REVISED
Hearing Examiner
Staff Report and Recommendation

Project Name: Shirley-Wetland Buffer Reduction for Single Family Residence (SFR)

Type of Application: Critical Area Variance (Type III) and Zoning Variance (Type II)

Permit Number: 22-03914 and 22-00285

6. Site Design

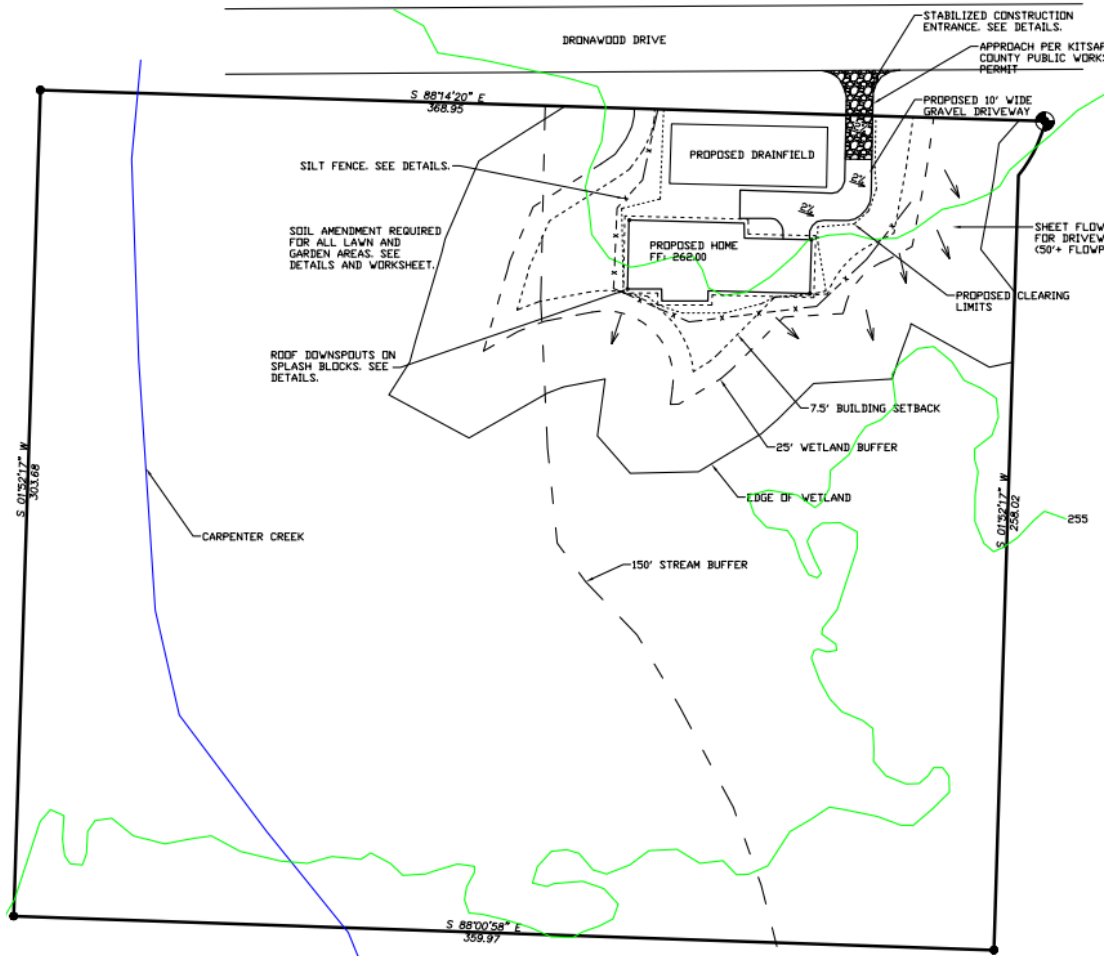
The image below shows the proposed footprint of the 1,617 square-foot home with attached garage, an associated drainfield, and the proposed driveway accessing from the north.
